**Response to**  
**Request for Additional Information No. 278, Supplement 5**  
**9/14/2009**

**U.S. EPR Standard Design Certification**  
**AREVA NP Inc.**  
**Docket No. 52-020**

**SRP Section: 05.02.03 - Reactor Coolant Pressure Boundary Materials**  
**SRP Section: 05.03.02 - Pressure-Temperature Limits, Upper-Shelf Energy, and**  
**Pressurized Thermal Shock**

**Application Section: FSAR Ch. 5**

Figure 5.3-1—Reactor Coolant System Heatup Pressure-Temperature Curve

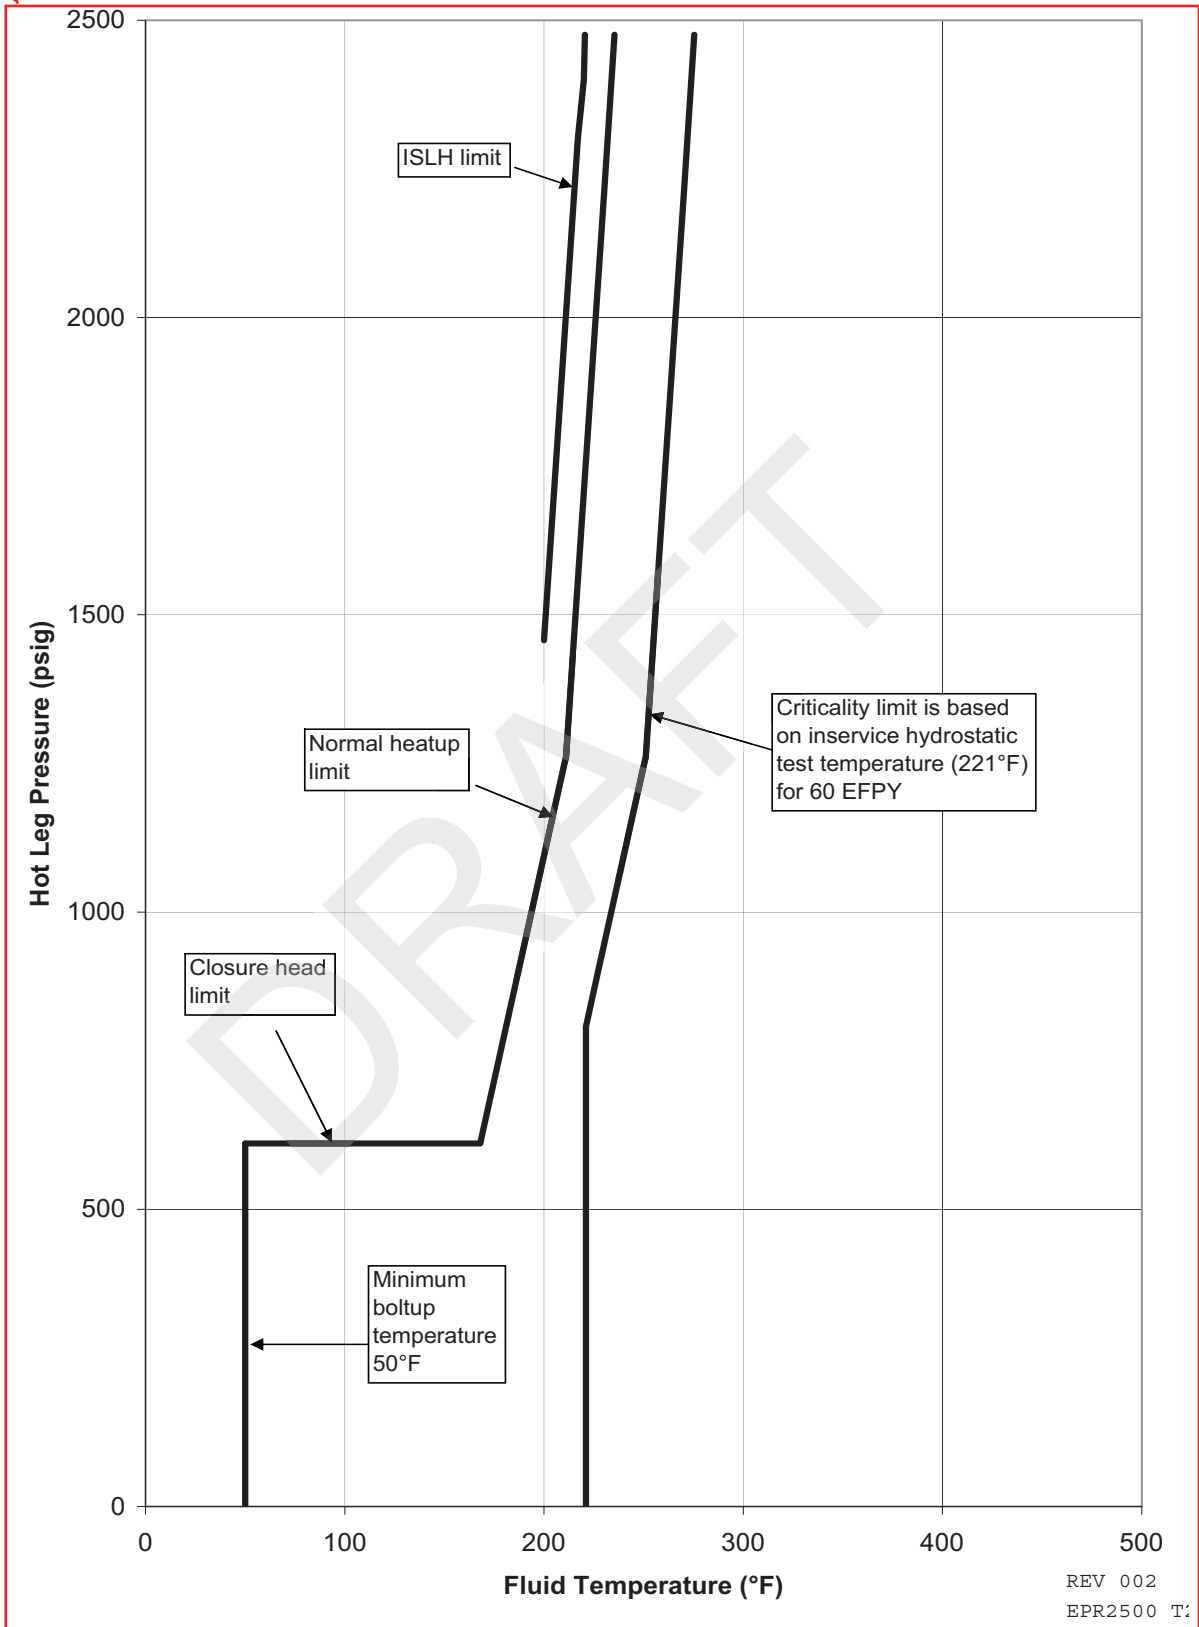
Provide a table of the data points (reactor coolant temperature vs. pressure) for each P-T curve displayed in Technical Report ANP-10283, Revision 1.

U.S. EPR FSAR Tier 2, Figure 5.3-1—Reactor Coolant System Heatup Pressure-Temperature Curve is also affected by the error identified in Figure 6-1. U.S. EPR FSAR Tier 2, Figure 5.3-1 will be revised to eliminate the error.

While preparing the response to this question, an error was identified in the criticality limit on Figure 6-1 in Technical Report ANP-10283P. This figure has been revised to eliminate the error. Table 05.03.02-7-1 contains the correct data points for the criticality limit.

U.S. EPR FSAR Tier 2, Figure 5.3-1 will be revised as described in the response and indicated on the enclosed markup.
